Docket Number:	15-AFC-01
Project Title:	Puente Power Project
TN #:	220221
Document Title:	Closing Testimony of David Revell Phd on Proposed Puente Site
Description:	N/A
Filer:	PATRICIA LARKIN
Organization:	SHUTE, MIHALY & WEINBERGER LLP
Submitter Role:	Intervenor Representative
Submission Date:	7/14/2017 5:08:54 PM
Docketed Date:	7/17/2017

MEMORANDUM

Subject: Closing Testimony on Proposed Puente Site

Figure 7. Snapshot of the OCOF tool data sets and descriptions. Data specific to or even the word erosion is not to be found. It is not yet possible to access the maximum wave run up data described under the flooding topic.

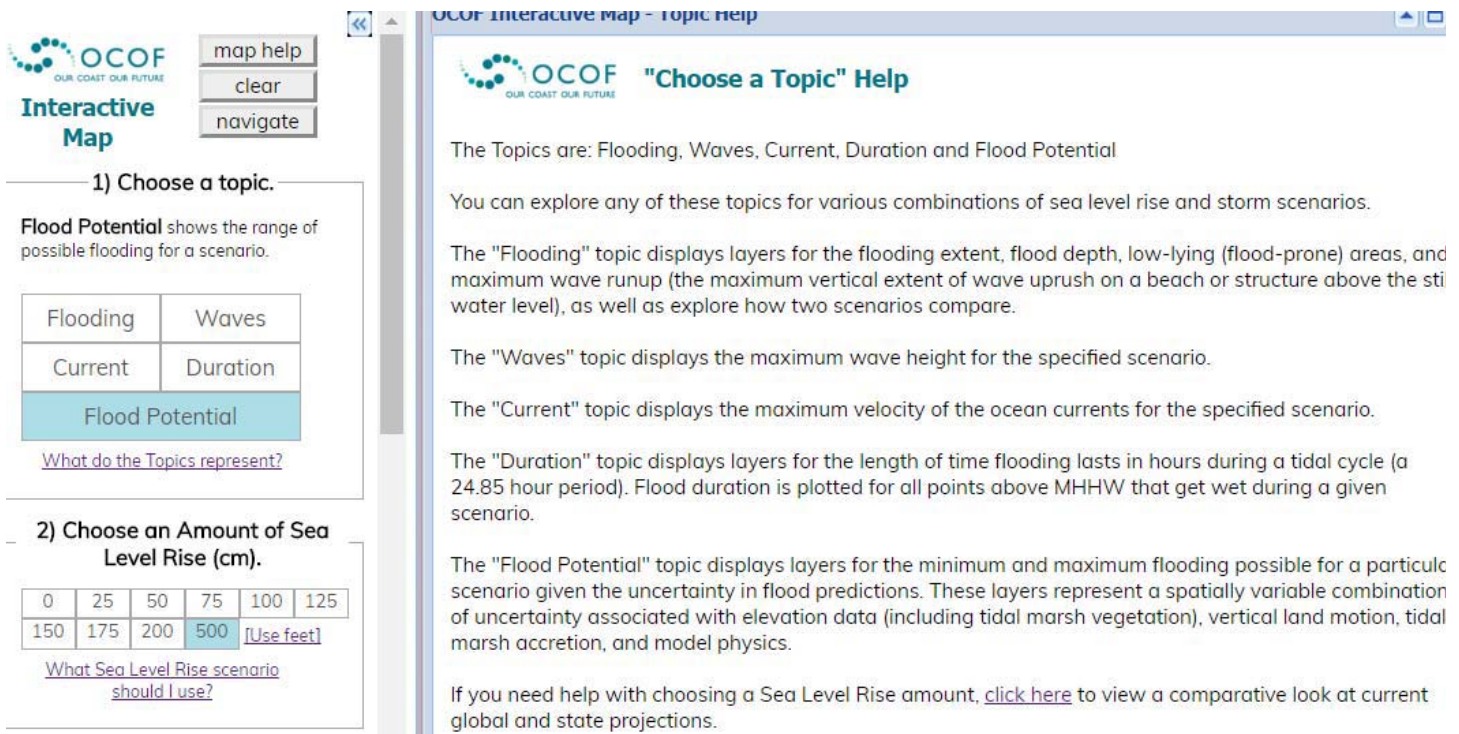
Presently there is no way to evaluate the erosion extent to the dunes caused by storms or sea level rise in either the COSMOS (Figure 7), or the FEMA model which aside from one lone analysis transect in Oxnard has largely failed to consider event based erosion as called for in the FEMA Pacific Coast Flood guidelines.
